May 17, 2006
JAFF-06-0079

**SUBJECT: James A. FitzPatrick Nuclear Power Plant
Docket No. 50-333
Response To NRC Request for Additional Information
Regarding FitzPatrick's Proposed Exemption Request
For Hemyc Fire Wrap (TAC No. MC7995)**

Attachment 1 to JAFP-06-0079
Entergy Nuclear Operations, Inc. – FitzPatrick
Docket No. 50-333
Response to Request for Additional Information (RAI)

Page 3 of 3
(Support RFSK-1829 Diagram and Photographs)

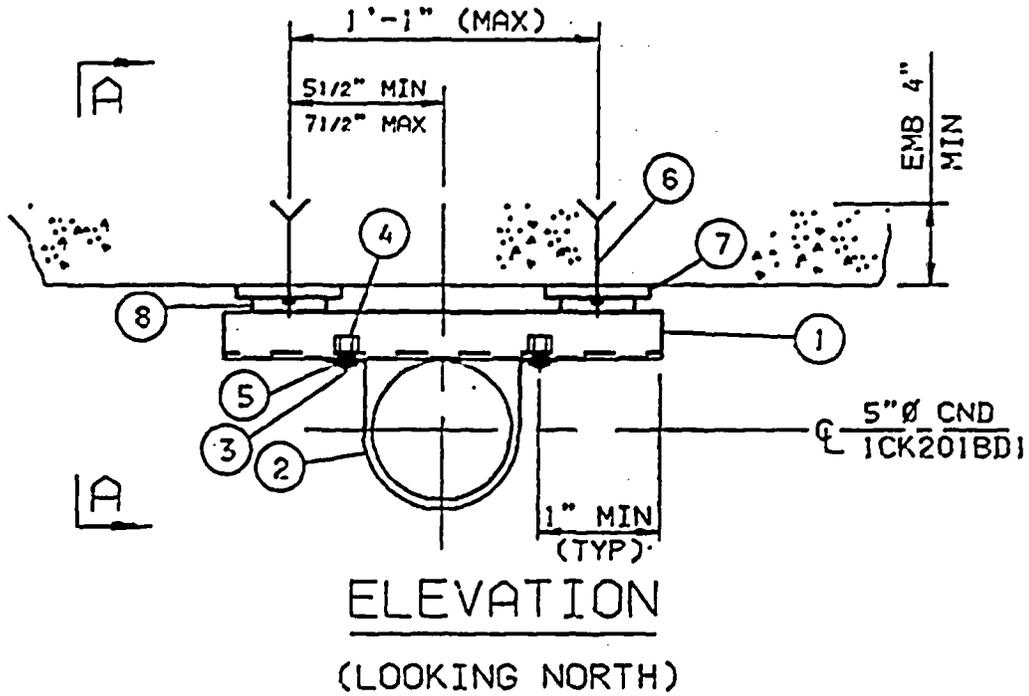
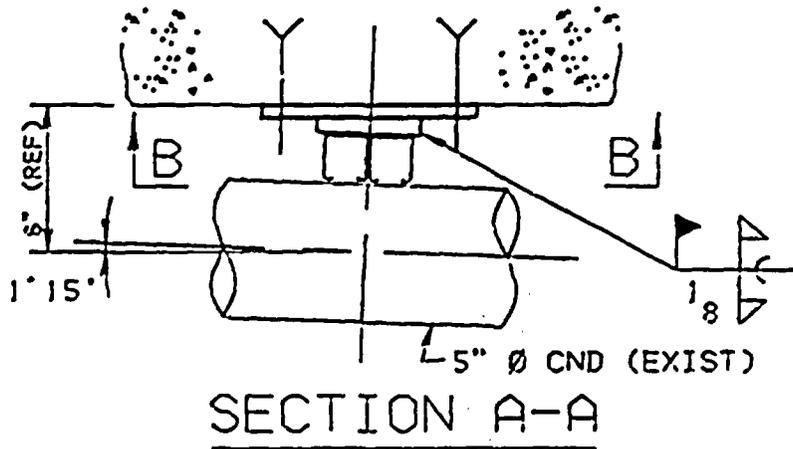
The submittal describes Hemyc wrapped structural supports. Steel supports were tested by the NRC separately from the conduit and found to fail as early as 13 minutes into the event. The additional heat load transferred to the conduit by the steel supports was not considered in the conduit tests. The FitzPatrick configuration is described as including five structural supports, completely wrapped except for a portion of the base plate. How has it been determined that the heat transfer from the exposed base plate would not adversely affect the protected cable? In the event of a fire, what would be the impact of heat transfer from the uncovered base plate through the supports to the conduit? In responding to these questions, please include the distance from the baseplate to the conduit containing the cable, and quantify the distance into an hourly rating using the NRC testing for similar supporting structures (angle iron, unistrut). Please also include the area of the base plate that is uncovered.

The structural support base plates are described as mounted in place with Hilti bolts to the concrete ceiling. Are these bolts covered by fire wrap? In the event of an intense fire, could concrete spalling compromise the ability of these bolts to function? If not, why not?

The effects of heat transfer from the exposed base plate have been evaluated based on a comparison of the JAF structural support configuration with the results of testing performed by the NRC, and engineering judgment.

The JAF structural support configuration utilizes multiple pieces of unistrut horizontally mounted to steel spacers. The spacers consist of square tube steel, steel plate, or “C” channel mounted to base plates which are mounted to a concrete ceiling with Hilti Kwik Bolt II anchor bolts. The steel support members attached to the base plates are entirely wrapped with Hemyc which results in most of the base plate being covered. The area of the base plates that is uncovered

varies, but is roughly the outer 2 inches on either end of the 6 inch by 12 inch plates, and roughly the outer 2 ½ inches on the exposed perpendicular edges and approximately 5 inches exposed at the corners of the 12 inch by 12 inch plate. The distance between the uncovered base plate and the conduit containing the cable is just over 5" for the limiting case. This was determined for support RFSK-1827, considering a linear distance from the uncovered base plate, across the wrapped portion of the base plate, the solid steel spacers, the double unistrut to the point where the conduit with the cable makes contact with the unistrut. See Attachments 3 through 8 for diagrams and photographs of the Hemyc wrapped supports.

The supports tested by the NRC consist of a single run of unistrut and tube steel cut and welded into an "L" shape. By interpolating the thermocouple data contained in the NRC test, the unistrut support would meet a 30 minute temperature rating (single point temperature increase of 325°F above ambient) at less than 4 inches in from the exposed end and the tube steel would meet a 30 minute temperature rating at approximately 6 inches in from the exposed end.

Based on the differences described, no direct comparison could be made between the NRC test results and the JAF configuration. However, in the event of a fire, it is reasonable to expect that given the location of the base plate and its mounting to a concrete ceiling, that the concrete would absorb much of the heat absorbed by the base plate. This absorption would result in less heat transfer along the support members to the protected conduit containing the cable. In this configuration, the concrete ceiling would function as a heat sink. In addition, given the thermal mass of the JAF support configuration that is protected, in comparison to that tested by the NRC (greater than double by observation), it is expected that a greater amount of heat would be required to raise the temperature of the steel support within the wrap, thus resulting in lower overall temperatures at 30 minutes. This is reasoned because there were no attachments to the simple unistrut and tube steel supports tested by the NRC, and heat transfer along the steel member progressed without heating adjacent structural members.

Based on the information presented above, the supports would be expected to provide at least a 30 minute fire rating. However, based on the fact that: (1) there are virtually no fire hazards in the area of the conduit, with the exception of fire retardant cables; (2) the area is protected by a full area wet pipe sprinkler system; (3) complete in tray wet pipe water spray system; and (4) full area fire detection, the potential to have an unmitigated fire substantial enough to challenge the integrity of the protected cable is non existent.

The Hilti Kwik Bolt II bolts used to secure the structural supports in place are not entirely covered by the Hemyc fire wrap as seen in the attached photographs. At the time the Hemyc wrap was installed, the need to wrap the base plates and Hilti bolts was evaluated using the guidance contained in NRC Generic Letter 86-10 (Reference 6) and it was determined that wrap was not required.

In accordance with option (b) above, this area is equipped with automatic area fire detection, automatic general area suppression and an automatic cable tray suppression system. The area is also equipped with fire hose stations and portable fire extinguishers in the immediate proximity. As discussed in the exemption request (Reference 4), the combustible loading in the area is composed primarily of fire retardant cables which pose a minimal fire hazard. In addition, ignition sources are negligible.

If a fire should occur, the early warning detection system would actuate and transmit an alarm to the control room. Upon confirmation of the fire, the fire brigade would be immediately dispatched to the area and would suppress the fire using available hose stations and/or portable fire extinguishers. If a rapid temperature rise were to occur prior to the arrival of the brigade, the automatic area suppression system would actuate to control and/or extinguish the fire, reduce the area temperature, and thus preclude the potential for support failure or significant concrete spalling. Considering the existence of the fire protection features in the area, it was determined that the exposed base plates and Hilti bolts were acceptable (Reference 7), even when the Hemyc wrap was considered to provide a 1 hour fire rating.
